Delegated Report

Householder Planning Application

Planning Application No: 20230999

Description: Erection of a single storey side and rear extension, and conversion of loft space with rear and front dormers.

Drawing number 2023/64 Existing

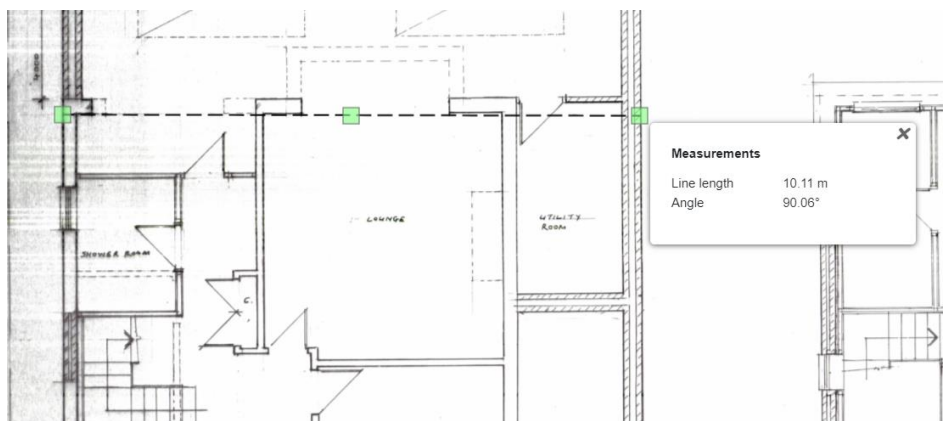
The property will increase in size from a three bedroom to four bedroom property which is acceptable. However, to achieve the design the physical width of the property appears to have increased to retain the garage width with a new cavity wall construction.

A difference of some 220mm, which whilst not necessarily significant gives the impression the garage width will be no worse than the existing situation. This additional width could only be achieved by building on the neighbour's property.

Whilst the existing garage may be substandard and does not comply with current guidance it was provided, presumably as a garage and so would have been taken into account as a parking space. However, the inevitable reduction in width due to the construction of a cavity wall means changes are taking place and it can no longer to be considered to be a car parking space, although it would serve for the parking of the cycles required by KCC SPG4 of one per bedroom.

The revised drawings, confirm the garage is no longer viable to park a car, but is suitable for the storage of cycles etc.

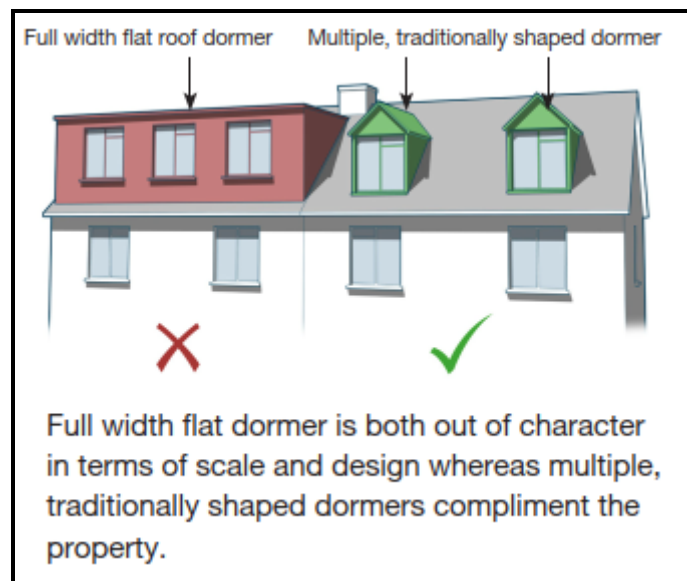
To the front elevation as visible from the street, the proposal would extend the roof, above the garage. It would retain the existing eave height and maintain the main ridge height of 5.85m. It would also introduce three dormer windows with half hipper roofs.

The proposed roof extension would extend above the garage but would retain the overall existing eave and ridge height. The impact visually would be the enclosing of the roof spacing with 1 Burghfield Avenue.

However, there would remain a 1 metre gap between the buildings and given that the building are both bungalows, there would be no terracing effect as a result of the change.

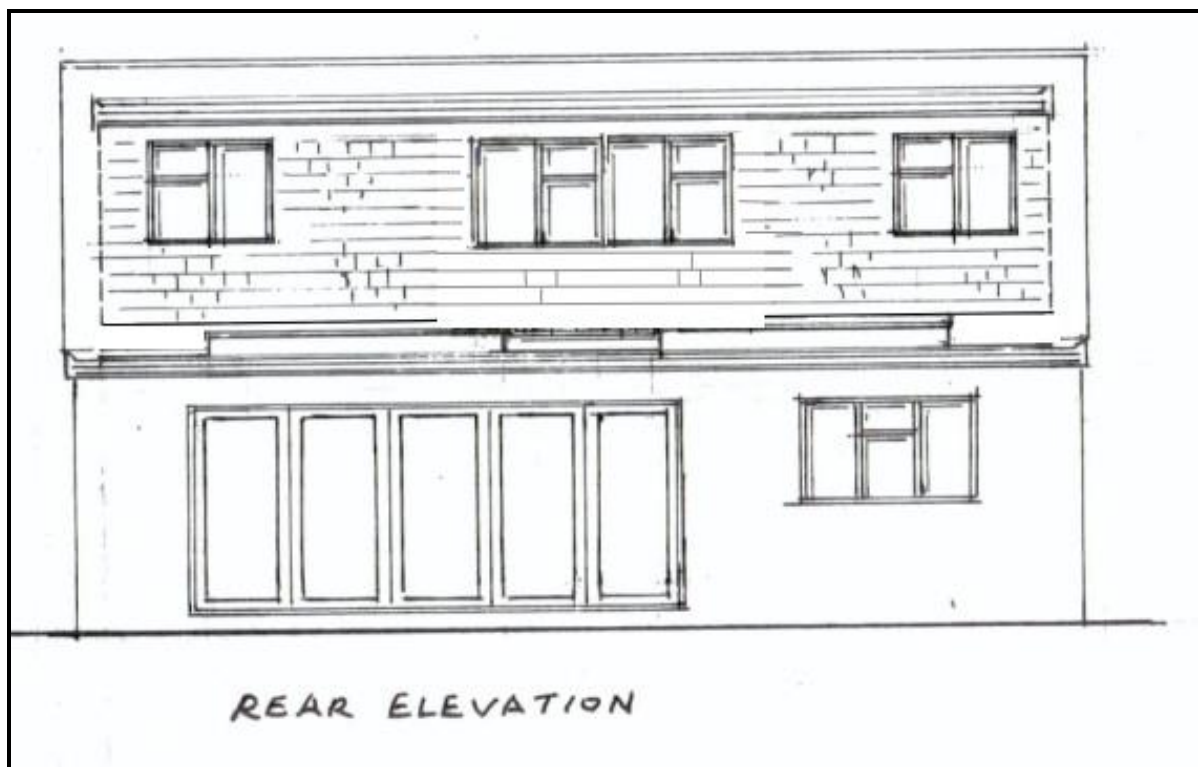
The Householder Extensions/Alterations Design Guide SPD advises under paragraph 10.10 that it will generally not be acceptable to create dormers on the front of a property whether there is not an existing established character of such forms in the immediately surrounding street scene. In this instance, whilst it is not a dominant character, there are instances of front facing roof dormers in the vicinity. 17, 23, 36, 38 and 39 Northumberland Road all have a flat roof dormer on the front roof slope. However, it is noted that the Design Guide makes a distinction between dormers which may be acceptable and those which would not as shown below.

In this instance, there is a wider existing character for front facing dormers in principle. However, the flat roof wide dormers which existing in the area will generally be resisted for their poor design to the front roof slope. This proposal would propose the appropriate multiple, traditionally shaped dormer as shown above. The scales of which would be appropriate and would be symmetrical in their location.
